Changes to clause 95 to include TxVEC

MMF ad hoc working document
July 2014

95.7 PMD to MDI optical specifications for 100GBASE-SR4

Figure 95–3—TxVEC conformance test block diagram

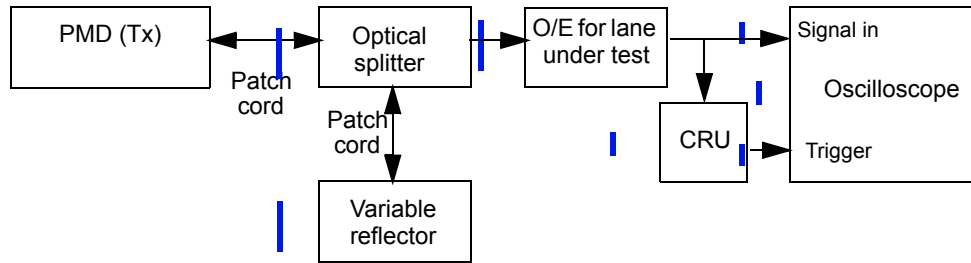
A block diagram for the TxVEC conformance test is shown in Figure 95–3. Other measurement

Each optical lane is tested individually with all other lanes in operation. The optical splitter and variable reflector are adjusted so that each transmitter is tested with an optical return loss of 12 dB.

The combination of the O/E and the oscilloscope used to measure the optical waveform has a fourth-order Bessel-Thomson filter response with a bandwidth of 12.6 GHz. Compensation may be made for any deviation from an ideal fourth-order Bessel-Thomson response.

The clock recovery unit (CRU) has a corner frequency of 10 MHz and a slope of 20 dB/decade.

Figure 95-4—Illustration of the TxVEC measurement

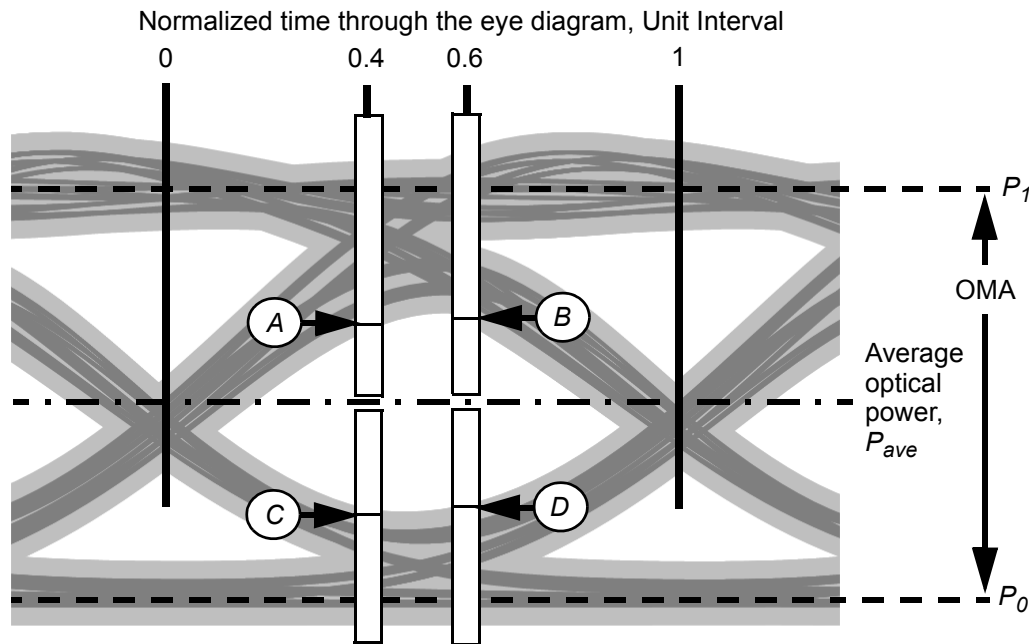
The oscilloscope is set up to accumulate samples of the optical eye diagram for the transmitter under test, as illustrated in Figure 95–4.

The 0 UI and 1 UI crossing points are determined by the time average of the eye diagram crossing points, as measured at P_{ave} , as illustrated in Figure 95–4.

Four vertical histograms are measured through the eye diagram, centered at 0.4 UI and 0.6 UI, and above and below P_{ave} , as illustrated in Figure 95–4.

Each histogram window has a width of 0.04 UI. Each histogram window has an inner height boundary which is set close to P_{ave} (so that no further samples would be captured by moving it closer to P_{ave}), and an outer height boundary which is set beyond the outer-most samples of the eye diagram, so that no further samples would be captured by increasing the outer boundary of the histogram. Starting from the boundaries closest to P_{ave} , the power at which the cumulative distribution of each histogram equals the 0.005th percentile of the total number of samples in the histogram is determined (these are the powers A , B , C , and

TxVEC is defined as the largest of the four quantities given by Equation (95-1) to Equation (95-4):
